**FAQ Number** 06-0012 Revision 4  
**FAQ Title** Determining Manual Actions that Require a Change Evaluation during Transition

Plant: Harris Nuclear Plant      Date: 03/22/2007  
Contact: Elizabeth Kleinsorg      Phone: 704.651.5548  
Email: ekleinsorg@haifire.com

**Attachment to FAQ 06-0012 Revision 4  
Excerpt from NEI 04-02 Revision 1 with Changes Tracked**

**Figure B-4 General Process to Transition Operator Manual Actions**

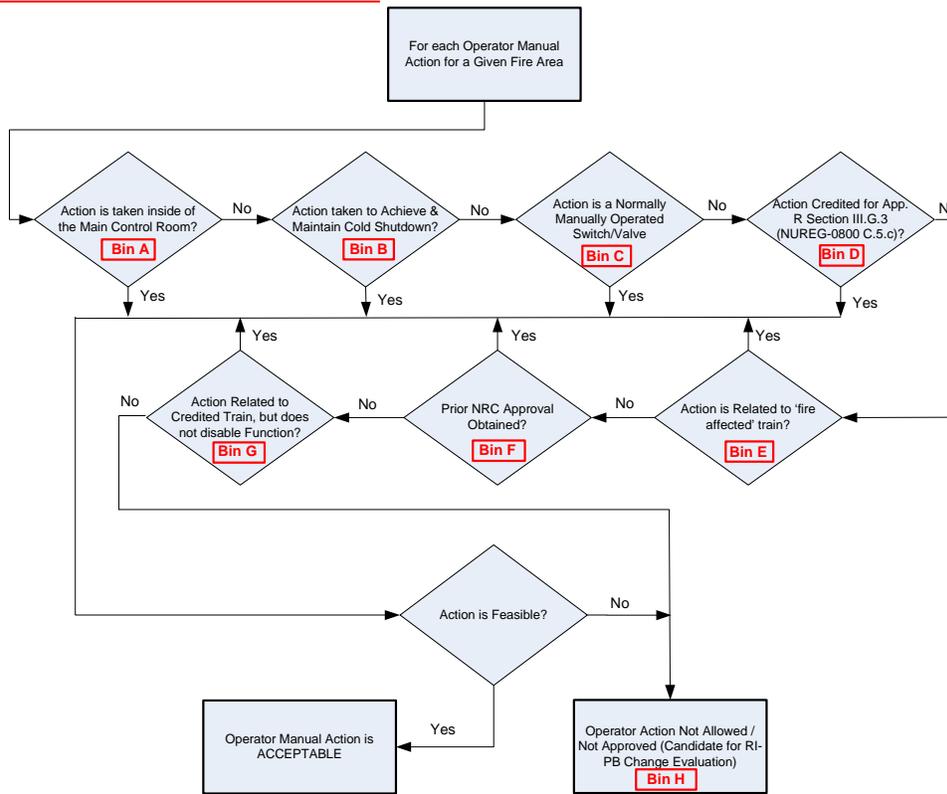
Figure B-4 depicts this general process for determining whether a transitioning operator manual action to NFPA 805 recovery action requires a change evaluation. The ‘bin’ identifiers are for ease of reference.

- Operator manual operation from the control room or emergency control station(s) [Bin A]
- Repairs or operator manual actions credited either for transitioning to or maintaining cold shutdown equipment [Bin B]
- Manual operation of normally operated manual switches and valves where separation/protection is provided for redundant safe-shutdown trains in accordance with Section III.G.1 or III.G.2 of 10 CFR 50, Appendix R (or applicable sections of NUREG-0800) [Bin C]

Figure B-5 Allowed Operator Manual Action in Fire Area Meeting 10 CFR 50, Appendix R, Section III.G.1 Separation Criteria

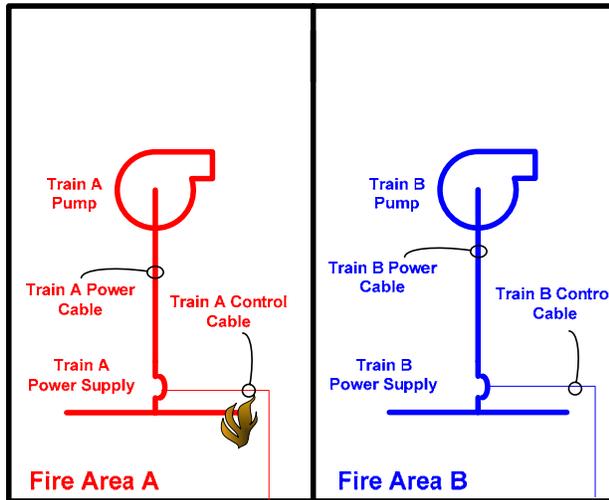
- Operation of fire affected equipment for fire areas that meet the separation requirements of Section III.G.1 of 10 CFR 50, Appendix R (or applicable sections of NUREG-0800). See Figure B-5. [Bin E]

Fire Area A and B meet the separation criteria of 10 CFR 50 Appendix R Section III.G.1. A postulated fire in Fire Area A could result in the spurious starting of the Train A pump, which can be mitigated by an operator manual action to de-energize the Train A Power Supply to stop Pump A.

Figure B-6 Allowed Operator Manual Action in Fire Area Meeting 10 CFR 50, Appendix R, Section III.G.2 Compliant – Operator Manual Action for Fire Affected Train

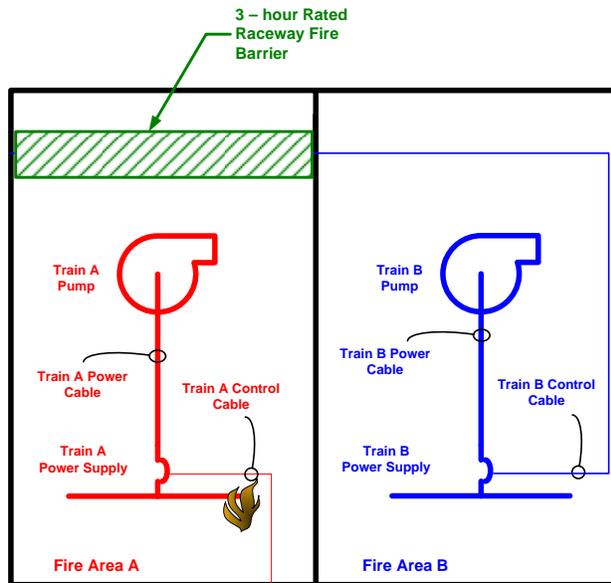
- Operation of fire affected equipment for fire areas that meet the protection requirements of Section III.G.2 of 10 CFR 50, Appendix R (or applicable sections of NUREG-0800) for redundant trains. See Figure B-6. [Bin E]

RIS 2006-10 states: “As discussed during a March 1, 2006, public meeting, if one of the redundant trains in the same fire area is free of fire damage by one of the specified means in paragraph III.G.2, then the use of operator manual actions, or other means necessary, to mitigate fire-induced operation or maloperation to the second train may be considered in accordance with the licensee’s fire protection program and license condition since paragraph III.G.2 has been satisfied.”

Fire Area B meets the separation criteria of 10 CFR 50 Appendix R Section III.G.2.a. A postulated fire in Fire Area A could result in the spurious starting of the non-credited Train A pump, which can be mitigated by an operator manual action to de-energize the Train A Power Supply to stop Pump A. This is functionally equivalent to Case in Figure B-5.

Figure B-7. Allowed Operator Manual Action – In Credited Success Path – Common Tank Suction

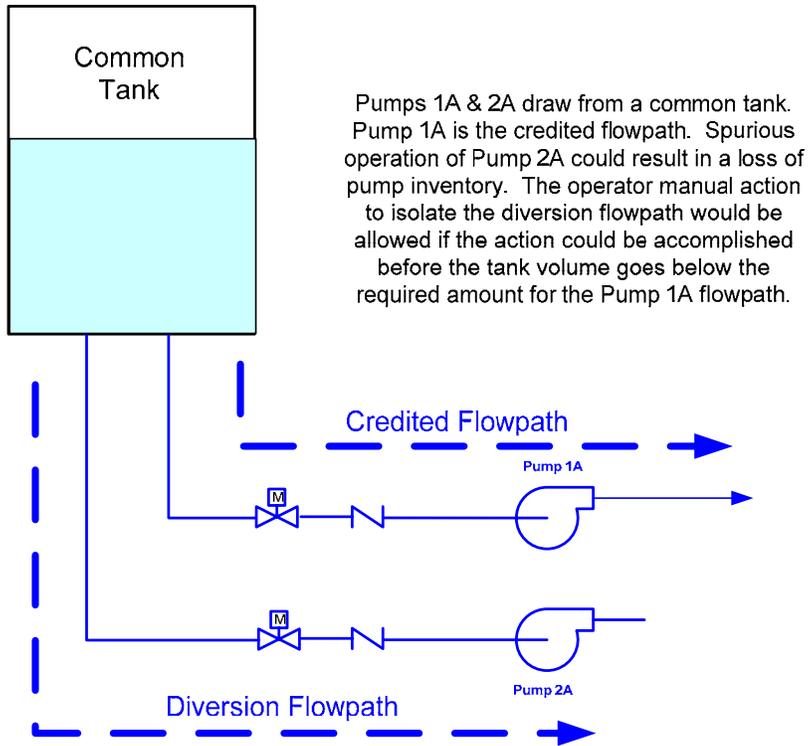
- Operator manual actions to address spurious actuations that affect the credited safe shutdown success path are allowed, as long as the spurious actuation is not directly in the protected train of the credited function (e.g., the main flowpath, as opposed to a diversionary flowpath) and the credited function does not become disabled during the time it takes to perform the operator manual action. See Figures B-7 and B-8 [Bin G]

During the June 9, 2006 public meeting the following example was specifically discussed: Two redundant trains taking suction from a common tank. Provided the manual action can be accomplished prior to the tank volume going below the minimum required volume to support the credited function the action would be allowed and therefore not require a change evaluation. (Figure B-7)

Figure B-8, Allowed Operator Manual Action – In Credited Success Path – Auxiliary Feedwater Flow Diversion

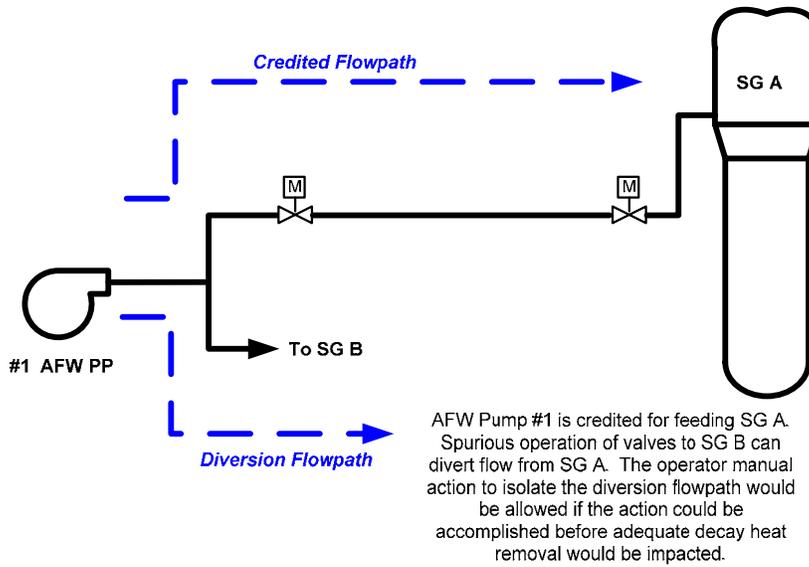
A second example is the credited function is to inject water to the Steam Generator (reactor) and a spurious actuation causes a diversion from the credited flow path. Provided the minimum required injection flow can be maintained and the operator action can be accomplished prior to the function being disabled. (Figure B-8)
